Transport and Works Act 1992 (TWA): Application for the Rother Valley Railway (Bodiam to Robertsbridge Junction) Order

Proof of Evidence: Level Crossings and Land Accessibility

Philip Clark

Reference: TWA/18/APP/02/OBJ/1002/PJC/1

Figure 2: Red Line Boundary Application Plan showing location of UWC/01 (CD:RVR/23)

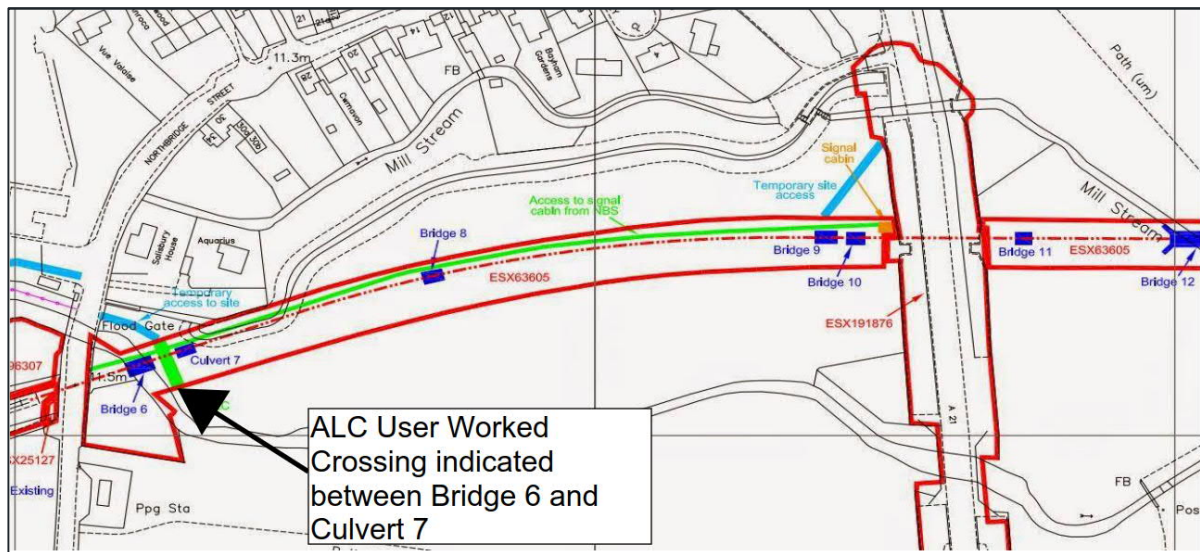
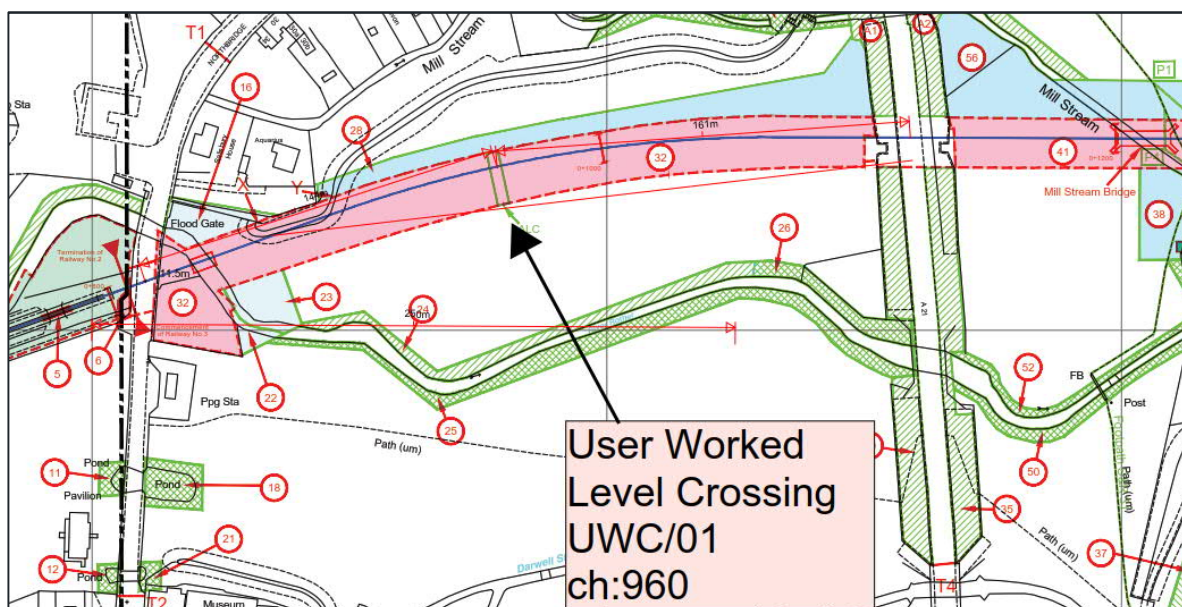
- 3.3.3. I note a discrepancy in the location of proposed User Worked Crossing (referred to in my proof as UWC/01) depicted on Order Plans (**CD:RVR/23**) between Northbridge Street and A21 that has bearing on land access and the operation of neighbouring level crossings. RVR drawing published by JC White dated July 2017 (**CD:RVR/23**) shows this UWC located adjacent to Northbridge Street, between Bridges 6 and 7, whereas the Works and Lane Plans (**CD:RVR/23**) show this UWC located further east, positioned centrally between Northbridge Street and A21. **Figure 2** and **Figure 3** below highlight the two different locations shown for UWC/01. Red Line Boundary Plan Showing UWC/01 Location (**CD:RVR/23**)

Figure 7: RVR Level Crossing Schematic

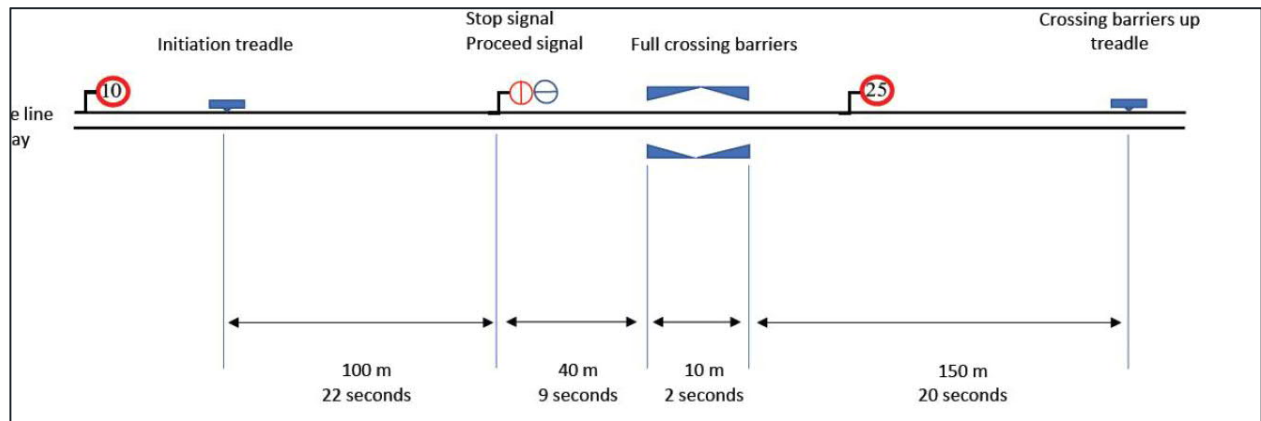
- 4.5.4. The schematic shows the crossing initiation treadle is 140m prior to the crossing points. **Figure 7** also indicates that the crossing barrier up treadle is 150m after the crossing. Approach speed of 10mph. The figure from RVR suggests that the same details will be present for the Northbridge Street, A21 and Junction Road.

- 4.5.7. The total transit time for a train travelling at 10mph (16kph) to the level crossing, a total distance of 140metres, is 31seconds. Based on the barrier close timings of 35 seconds presented in **Table 2** and **Figure 7** above, if the approaching train failed to stop at the crossing protection signal, and in the absence of any automated train detection systems to bring the train to a halt, or DWL at the crossing, the train is capable of reaching the level crossing before the barrier close sequence is complete.

Figure 20: Extract from ARUP General Arrangement (CD:RVR/75)

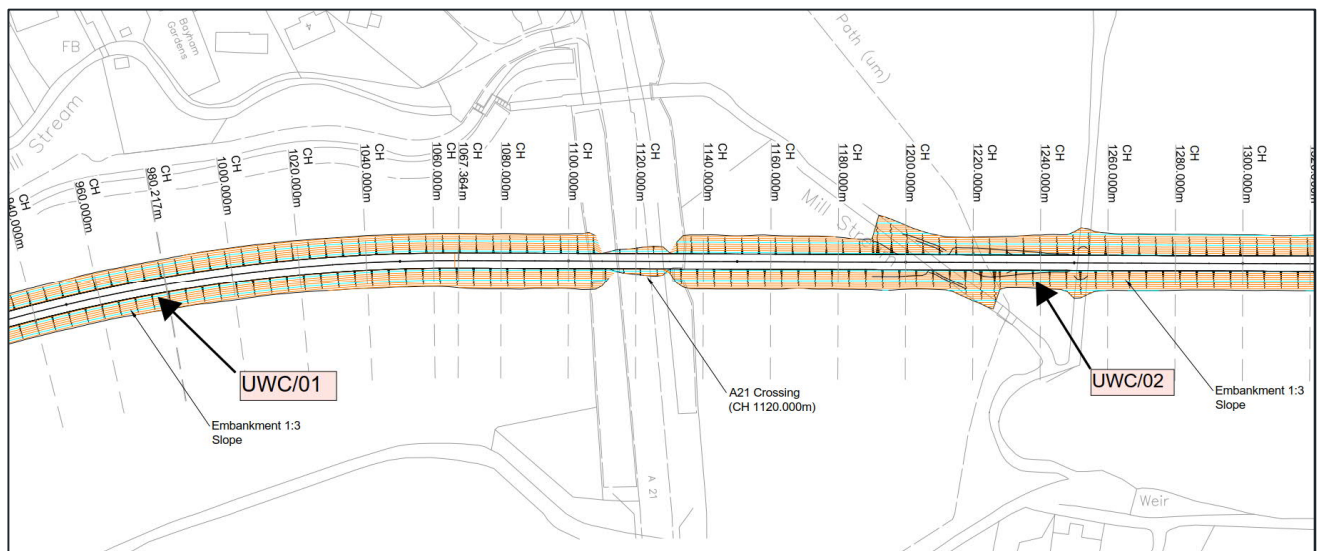
- 7.1.4. What is apparent from **Figure 20** and **Figure 21** is the absence of any provisions for earthworks and associated construction to accommodate vehicle ramps required to gain access up to the proposed farm access level crossing, as it is unreasonable and impracticable for my client to negotiate a 1:3 embankment to cross the level crossing.
- 7.1.5. Furthermore, Section 2 of the Level Crossing Guide for Managers, Designers and Operators (**CD:REP/17**) provides guidance on the appropriateness of approach gradients and need to avoid sudden changes in vertical gradients.

Figure 21: Extract from RVR-UB12-01 Mill Stream Bridge (CD:RVR/75)

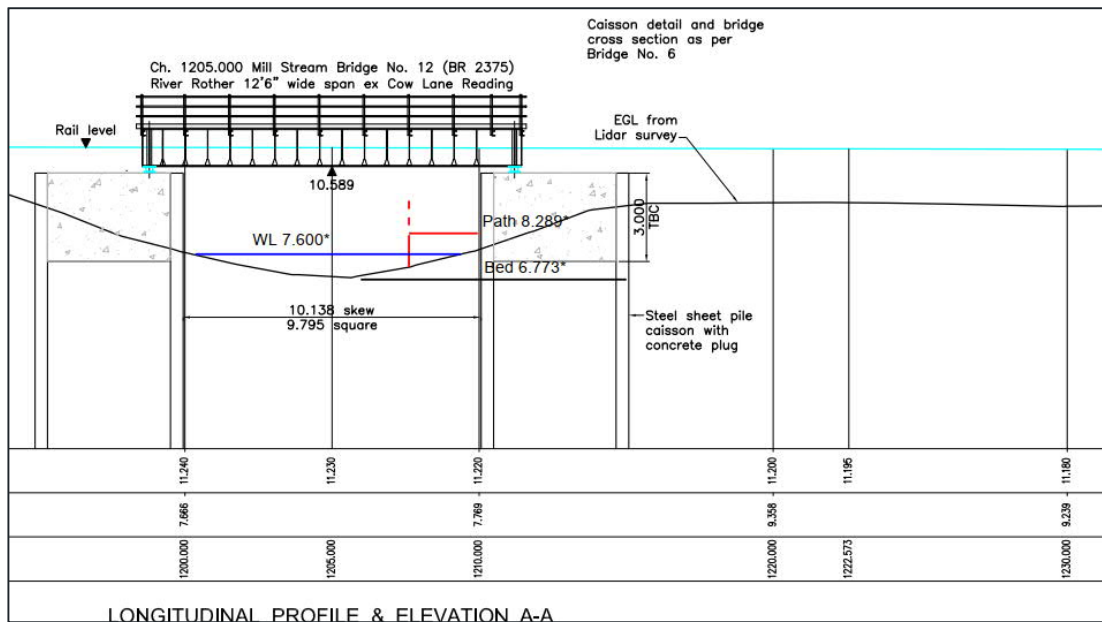
- 7.1.3. **Figure 21** presents an extract from Halcrow drawing RVR-UB12-01 Mill Stream Bridge (**CD:RVR/75**) depicting a longitudinal section of the track in vicinity of Mill Stream and UWC/02, that is consistent with **Figure 20** above. Ground levels at this location are indicated to be approximately 9.3m AOD, with a track level of approximately 11.19m AOD, equating to a level difference of 1.9m.

Figure 22: Annotated extract from ARUP 2390325-A21-G-001 CD:RVR/23

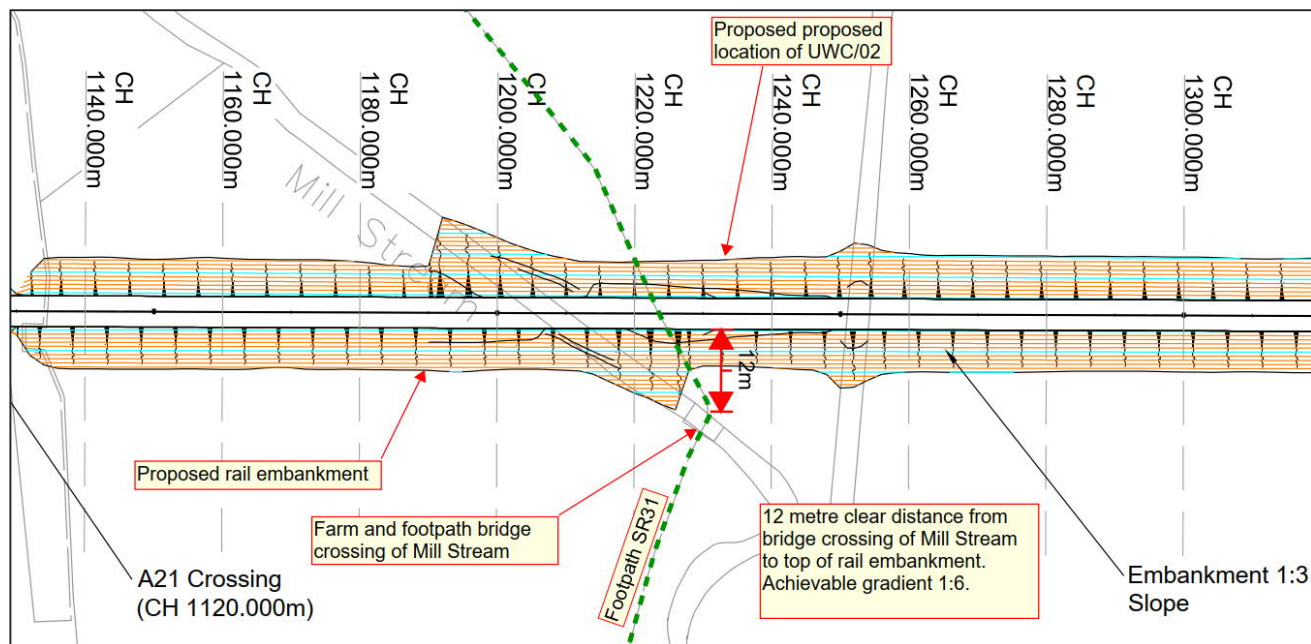
- 7.1.6. Examining the proposed location of UWC/02 in more detail, I present an extract from ARUP drawing 2390325-A21-G-001 to illustrate the setting of the raised embankment in relation to existing ground level, proximity to Mill Stream and associated bridge crossing conveying public footpath SR31 and agricultural access to onward land parcels south of the railway.

Figure 25: Deficient crossing sighting distance

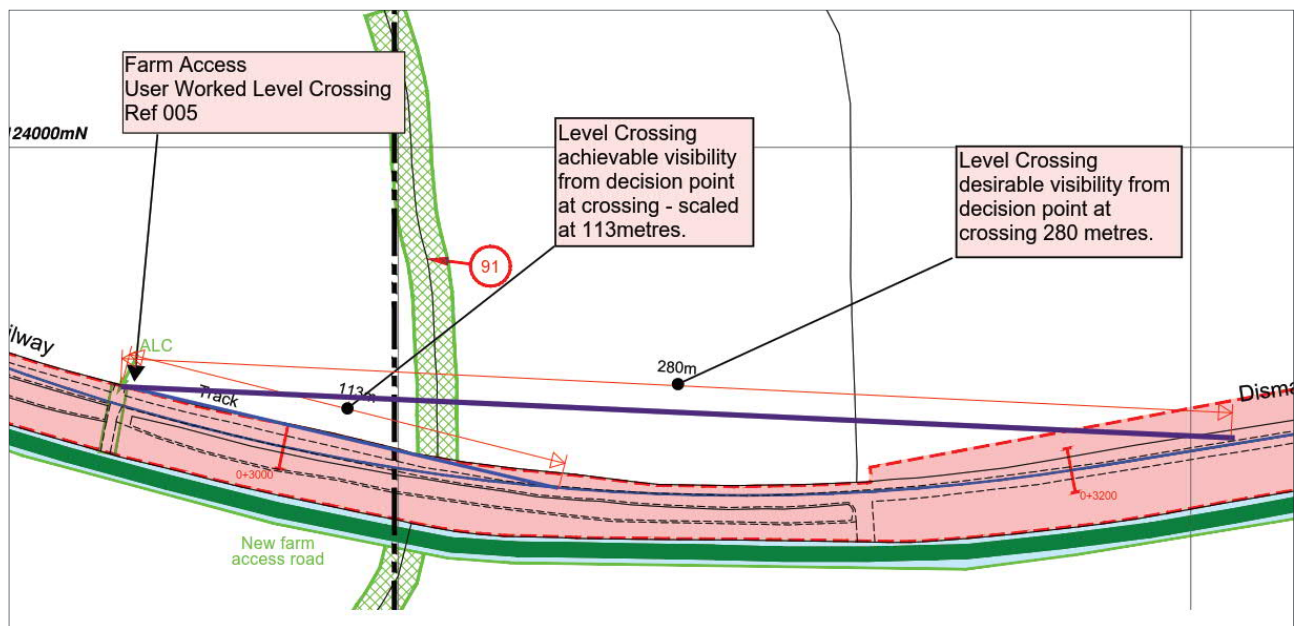
- 7.2.3. In the case of UWC/005, by plotting the 280m sighting distance it is evident that the desirable sighting distance is not achievable within the application boundary and would require additional land take and loss of hedgerow and trees. **Figure 25** shows the area required to achieve a suitable visibility envelope (with much of the required space outside of the red line boundary).

Figure 26: Deficient crossing sighting distance

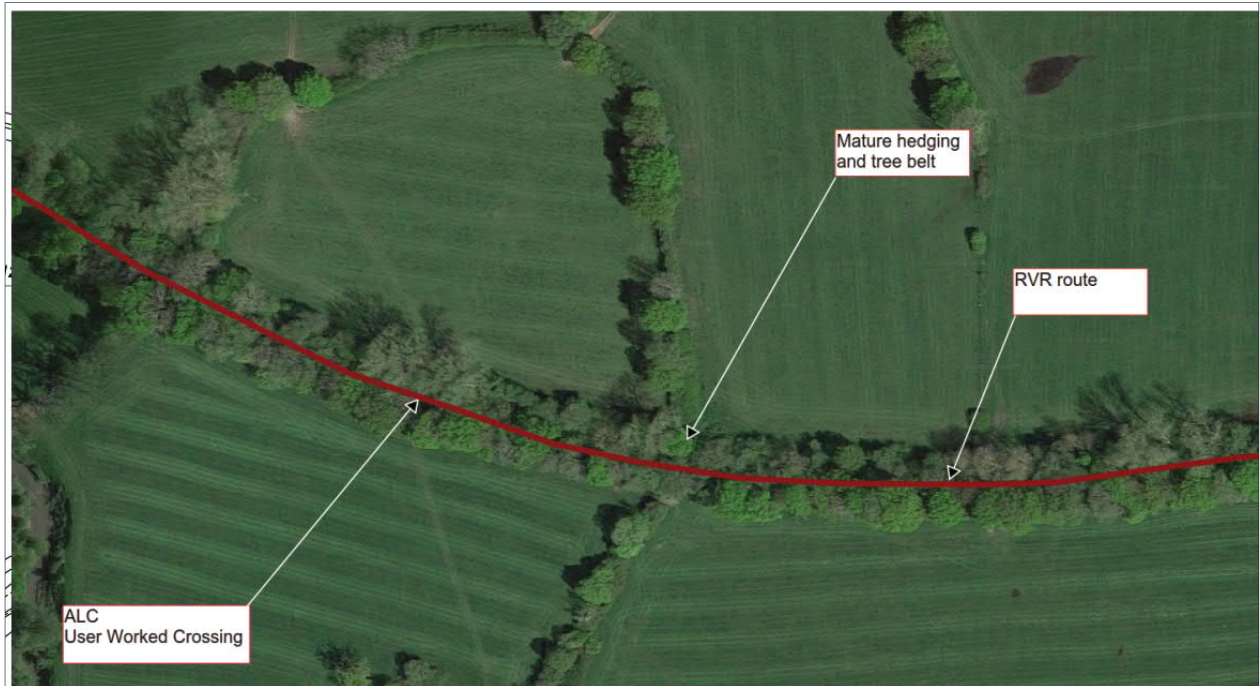
- 7.2.4. **Figure 26** shows an aerial photo of the same section of route, which clearly shows mature trees and hedgerows within the visibility splay area that would be affected by the proposals. It is unlikely that the environmental impacts of achieving a compliant visibility splay have been considered within the proposals since the area is outside the ES assessment boundary.

Figure 28: Level Crossing sighting - extract from Land Plans (CD:RVR/23)

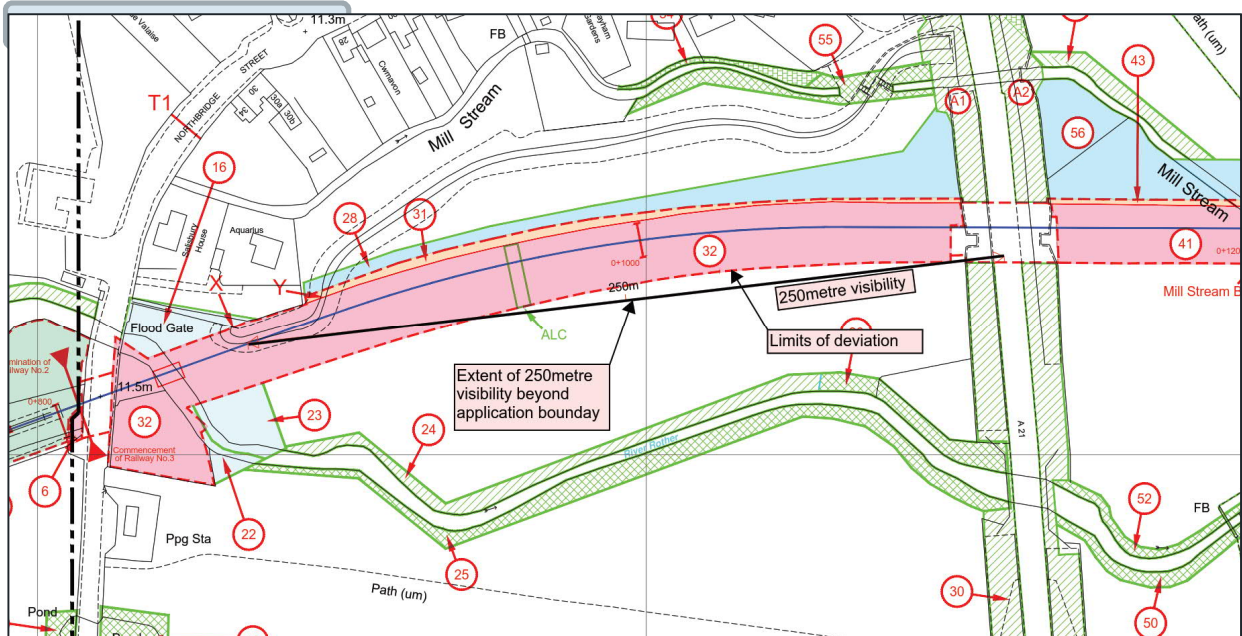
- 7.2.10. On the basis of the evidence presented in **Figure 27** and **Figure 28**, I do not consider the current application to be compliant with the stated provisions, and the works will not be deliverable within the application boundary. This increased land take may have an additional cost which has not been factored into the scheme and would also have environmental impacts that have not been assessed.

Figure 29: Extract from 239025 ARP-XX-XX-DR-CH-0002 P1

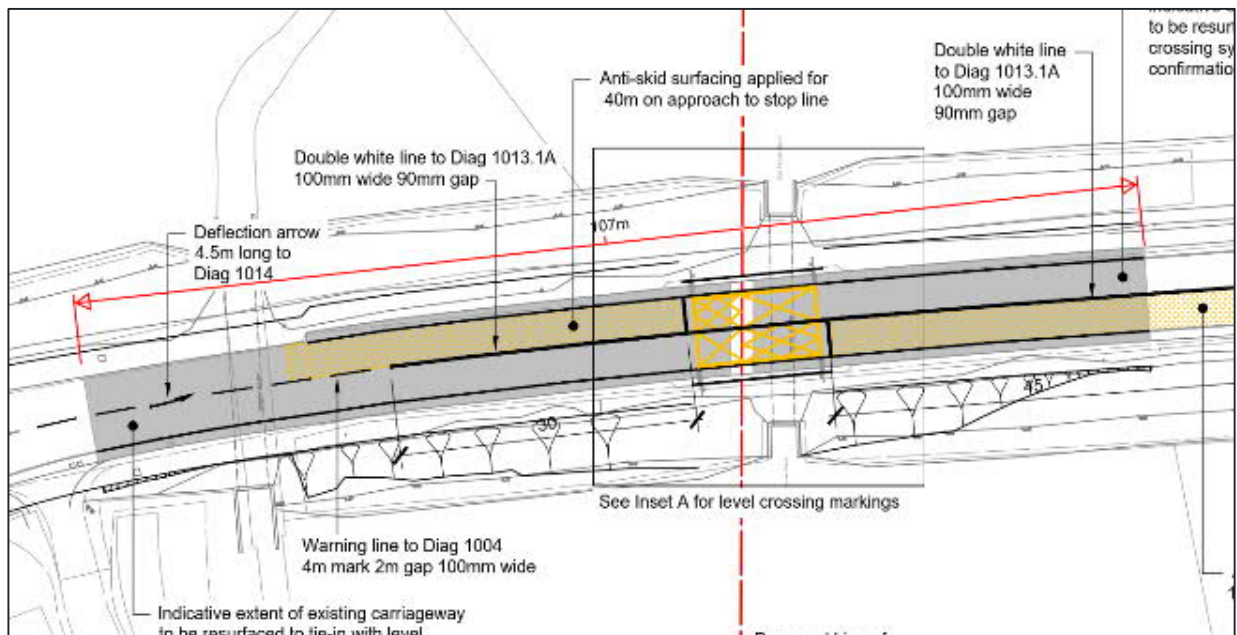
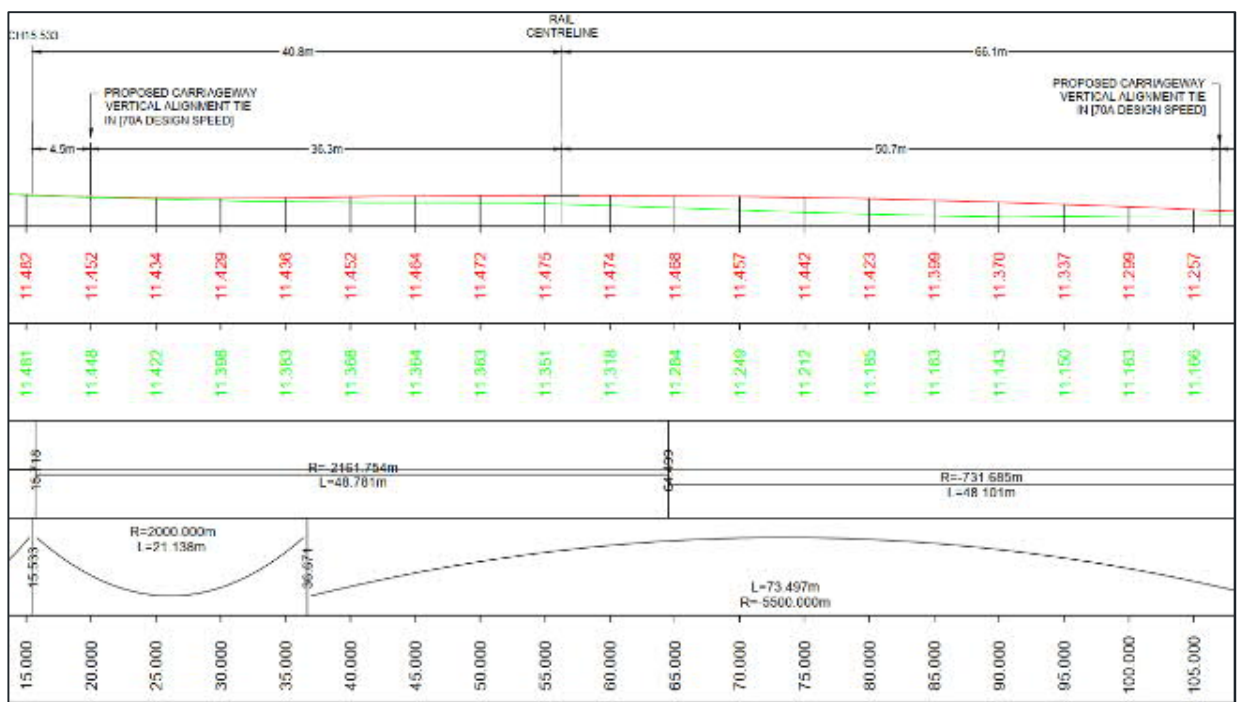
- 7.3.6. Extracts of drawings 239025 ARP-XX-XX-DR-CH-0002 P1 A21 Road Markings, and C.950.G.201 P2 A21 Proposed Geometry are presented below in **Figure 29** and **Figure 30** to illustrate the extent of regrading of the A21 carriageway, extending approximately of 41m to the south, and 66m to the north. An overall distance of approximately 107m.

Figure 31: Extract from ARUP drawing

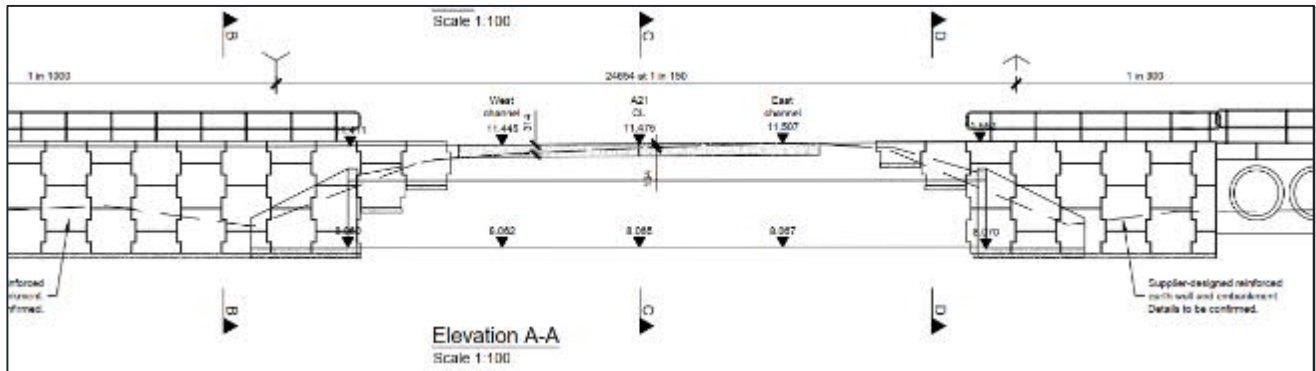
- 7.3.7. The proposed resurfacing of the A21 road also introduces a change to crossfall to align the carriageway with the rail track bed. To visualise proposed changes to the A21 cross, **Figure 31** below presents an extract of ARUP drawing 239025-ARP-XX-XX-DR-CB-0001 Embankment Retaining Wall General Arrangement and Sections, (**CD:RVR/74-6**) shows detail of the proposed levels and track gradient. The northbound carriageway is to be raised by in excess of 314mm. The carriageway crossfall will change to be equal to the track gradient of 1:150.

- 7.3.8. This change has the effect of reducing (flattening) the crossfall gradient, from 1:25 down to 1:150. To understand the implication of this change and the effect on the drainage of surface water I draw attention to the DfT publication DMRB CD 109 Highway Link Design (Design Manual for Roads and Bridges, 2020) that prescribes very specific design requirements for highway design. Table 2.10 of this document, illustrated in **Figure 32** below, defines the applicable superelevation for a prescribed design speed and road curvature.

Figure 34: Extract from RVR-UB12-01 Mill Stream Bridge (CD:RVR/75)

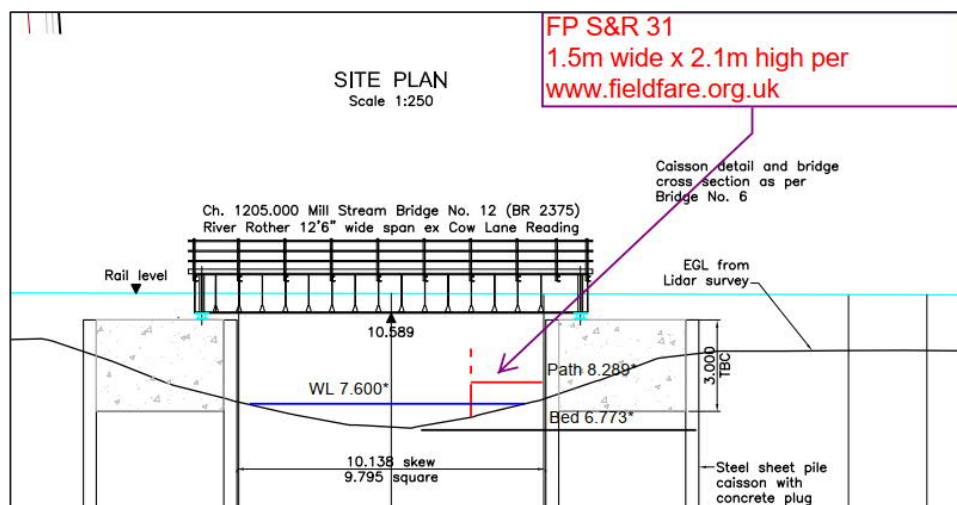
- 7.5.3. Halcrow drawing RVR-UB12-01 Mill Stream Bridge (**CD:RVR/75**) provides a detail illustrating the arrangements to divert footpath SAL31/1 to under river bridge UB12, as illustrated in **Figure 34** below. The proposal involves diversion of the footpath to within the existing river channel to a level of approximately 8.5m AOD, providing a headroom clearance of 2.1m. The proposed path level is approximately 1m below existing ground level.
